PALMER WOODS SUBDIVISION,
PHASE III

Revised for the May 3rd meeting:

APPLICATION NUMBER Holdover DATE May 3, 2007

DETAIL SITE PLAN

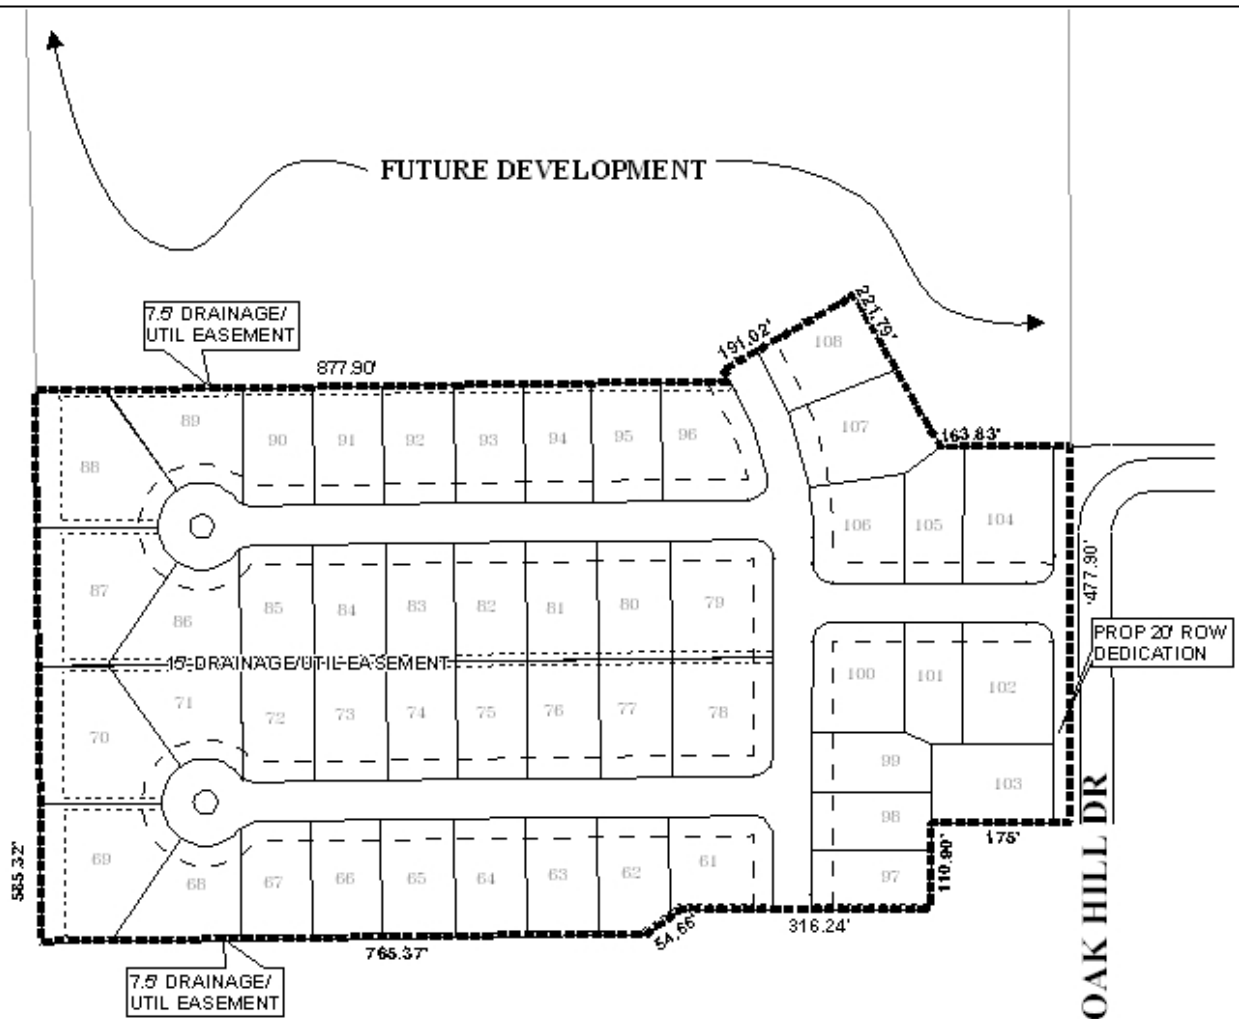
Oak Hill Drive, which has an existing right-of-way of 60-feet, is a proposed major street (Magee Road) on the Major Street Plan, and as such requires a 100-foot right-of-way. Therefore, as illustrated on the preliminary plat the dedication of sufficient right-of-way to provide 50-feet from the centerline of Oak Hill Drive, should be required.

With the site being located on a major street, access management is a concern; therefore, the placement of a note on the Final Plat stating that Lot 103 is allowed one curb cut to Oak Hill Drive, with the size, location and design to be approved by Mobile county Engineering, should be required. As proposed, Lots 102 & 104 would have frontage along Oak Hill Drive and the new street; therefore, the placement of a note on the Final Plat that Lots 102 and 104 are denied direct access to Oak Hill Drive, should be required.

As stated on the subdivision application public water and sewer would be provided; however, MAWSS comments state that NO water or sewer services are available. Based on the preliminary plat the majority of the lots do not meet the minimum requirements of Section V.D.2 “Where served by neither the public or an approved private water supply system nor sanitary sewer system the minimum lot size must be at least 20,000 square feet”.

Prince Court and Collie Court, the cul-de-sacs proposed for this phase of the subdivision, are approximately 720± feet long, which exceeds the 600-foot length, recommended in Section V.B.6. of the Subdivision Regulations. Therefore, a waiver of Section V.B.6 would be required.

The requirement for street-stubs to the North is based upon Section V.B.1. of the Subdivision Regulations, which states: “The street layout shall also provide for the future projection into unsubdivided lands adjoining of a sufficient number of streets to provide convenient circulation.” The remaining parcel of the site is approximately 77 acres, and is likely be the subject of future subdivision applications, hence the recommendation for street-stubs.

The applicant submitted revised information regarding the application. The information provided clarifies the issues previously identified. However, minimum building setbacks for Lots 102, 103 & 104 are not illustrated on the preliminary plat; therefore, the placement of the minimum building setbacks for these lots should be illustrated on the Final Plat.

The plat meets the minimum requirements of the Subdivision Regulations and is recommended for Tentative Approval subject to the following conditions:

- 1) the dedication of sufficient right-of-way to provide 50-feet from the centerline of Oak Hill Drive;*
- 2) the placement of a note on the Final Plat stating that Lot 103 is allowed one curb cut to Oak Hill Drive, with the size, location and design to be approved by Mobile County Engineering;*
- 3) the placement of a note on the Final Plat stating that Lots 102 and 104 are denied direct access to Oak Hill Drive;*
- 4) the placement of the minimum building setback lines along Oak Hill Drive on Lots 102, 103 & 104;*
- 5) provision of the minimum requirements of Section V.D.2;*
- 6) provision of a certification letter from a licensed engineer to the Planning Section of Urban Development, certifying that the stormwater detention, drainage facilities, and*
